Report under section 87F of the Resource Management Act 1991 on a notified resource consent application by Panuku Development Auckland Limited for consent for the construction, occupation, use and maintenance of permanent and temporary infrastructure and undertaking of activities within the coastal marine area and on land, associated with the America's Cup

From: Nicola Broadbent – Reporting Planner

Auckland Council Reference Numbers: BUN60318372

Figure 8: Proposed AC Wynyard Hobson Predicted Construction Traffic Demands³²

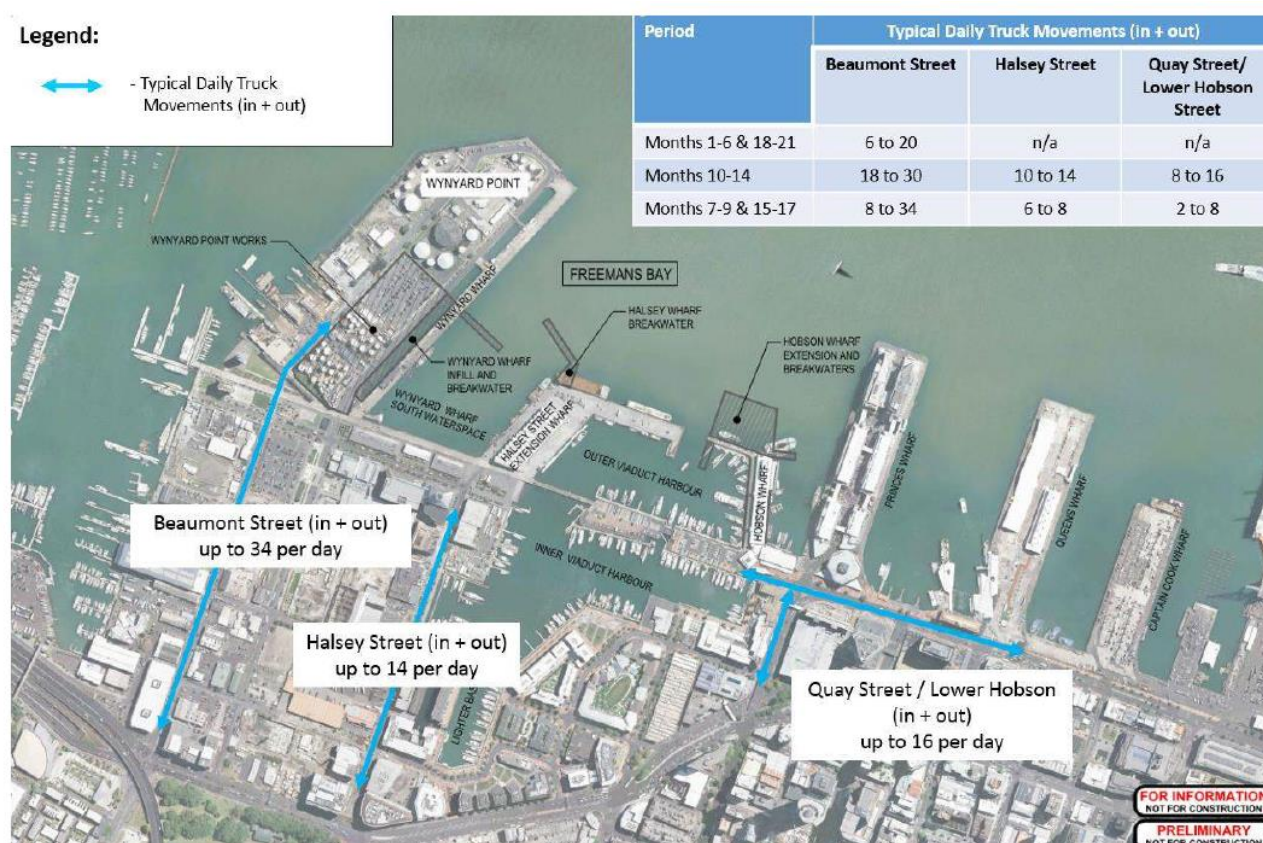
- 6.2.6 The Beca TA report, Figure 7-4 is copied below in **Figure 8** and highlights the estimated typical truck generation during the various stages of construction on the construction routes.

6.2.7 The typical daily truck generation for the AC36 construction works is predicted to occur on Beaumont Street with up to 30 to 34³³ truck movements per day, which equates to 3 to 4 truck movements per hour (assuming an 8 to 10 hour working day). This level of truck traffic is anticipated to occur for 11 months (month 7 to month 17). AC36 construction traffic is anticipated to include 1 to 2 truck movements per hour each on Halsey Street and Quay Street/Lower Hobson Street over the entire construction period.

The location of the temporary truck layover areas as shown in Figure 7-4 of the Beca TA report is considered appropriate for the purpose and should be included in the CTMP condition of consent, with conditions that require them not to impede the passing of other vehicles.

Figure 13: Proposed Access and Traffic Management Arrangements for Hobson Wharf during the Operational Phase

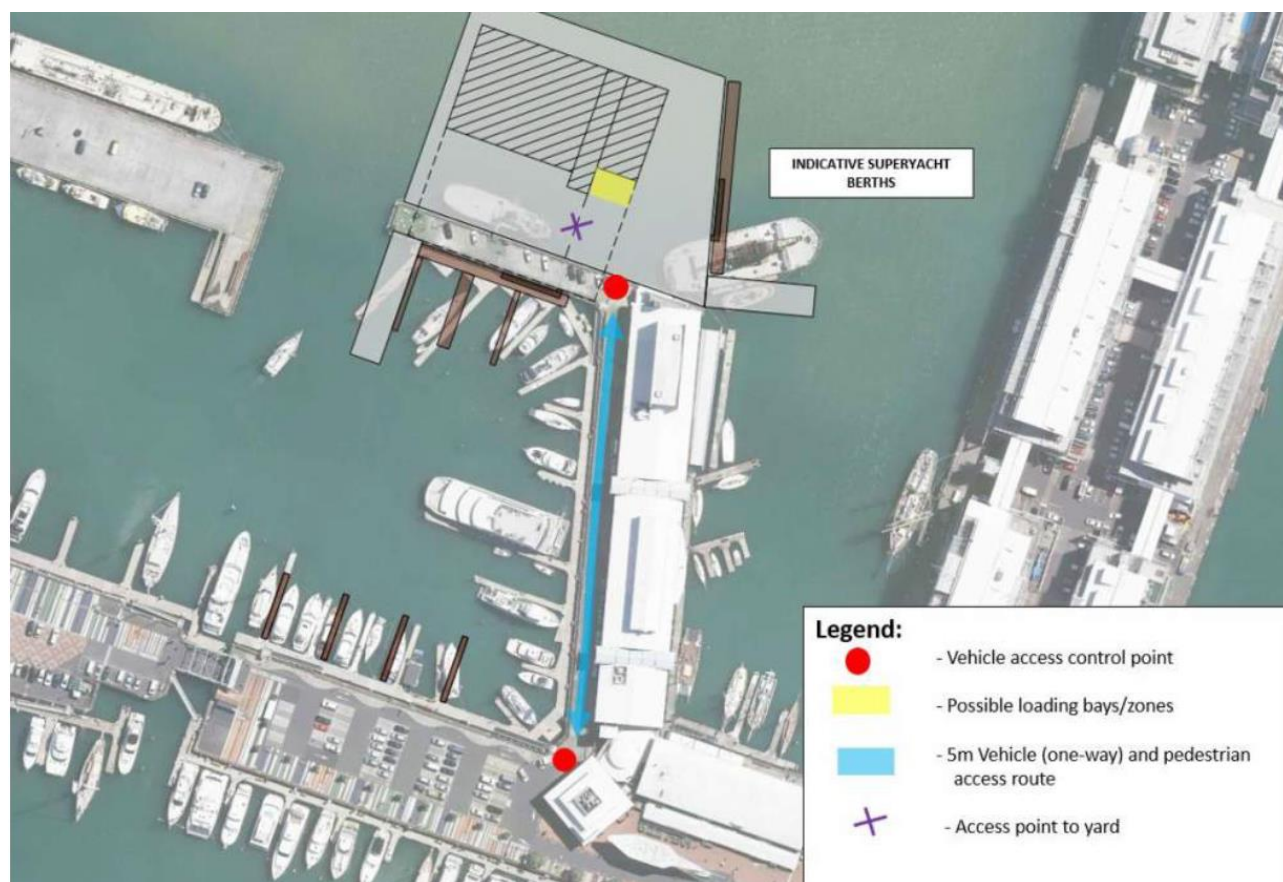
7.4.1 **Figure 13** summarises the arrangements for the Hobson Wharf base during the Operational Phase. We understand (from a meeting with the Applicant on 6 June 2018) that no parking or drop off/pick up will be provided on the wharf. Drop off and pick up will be from existing facilities outside the Maritime Museum.

Figure 15: Indicative Event Management Approach⁶⁹

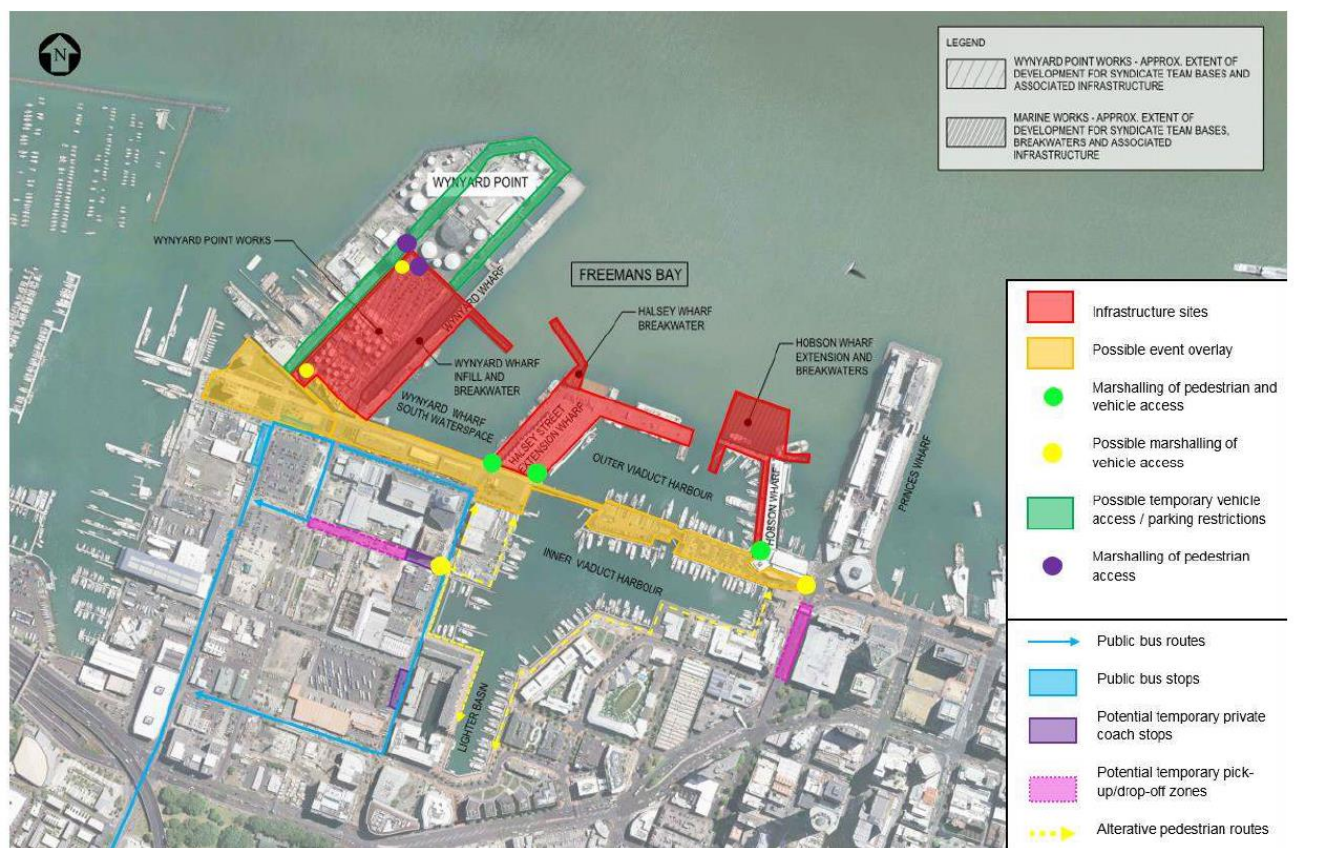
8.3.10 We are not convinced that this alternative proposition is viable, as the distance to travel on this southern route is considerably longer for pedestrians, and cyclists would face the busy section of path in front of restaurants around the Eastern Viaduct, when compared to using the Wynyard Crossing bridge.
